BULLETIN #136

**P-50, P-61, P-63, P-63A DETROIT® SERIES
50 AND SERIES 60 ENGINE BRAKES.**

**INTRODUCTION OF NEW HOUSING HOLD
DOWN BOLTS AND APPROPRIATE TORQUE
VALUES.**

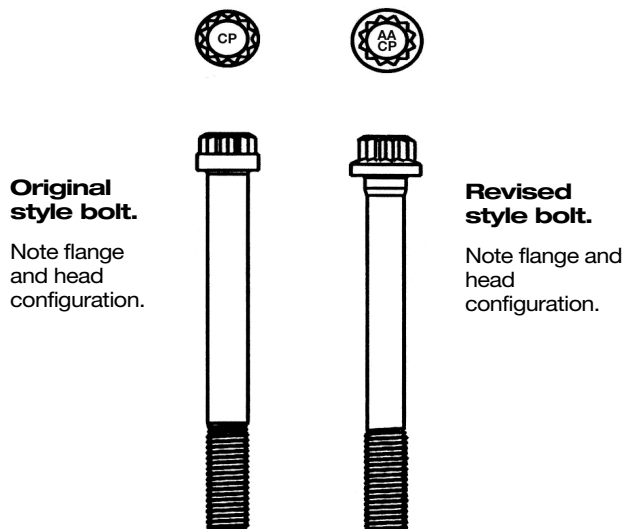
Pacbrake has redesigned the P60021 housing hold down bolt. The changes to the bolt afford better housing alignment and increased bolt torque. These new bolts can be used on all old and new model applications. The noticeable changes to the bolt are the flange below the head, the added shoulder below the flange and the identification markings on the top of the head. The diagrams below distinguish these differences clearly.

The new bolt torque values have been increased to 100 lbs.ft. (136 N•m). The old style bolt torque values remain at 80 lbs.ft. (110 N•m). Special attention must be paid when servicing the above application to ensure the correct torque is applied to these bolts. **DO NOT MIX BOLT TYPES ON INDIVIDUAL HEADS.** If bolts are mixed the lower torque value must be used.

The part number P60021 will be used for both the old and new style bolts. All new orders will be filled with the redesigned bolt. Field inventory of the old style bolt should be exhausted prior to using the new design.

Pacbrake does not recommend mixing bolt types when servicing the engine brakes.
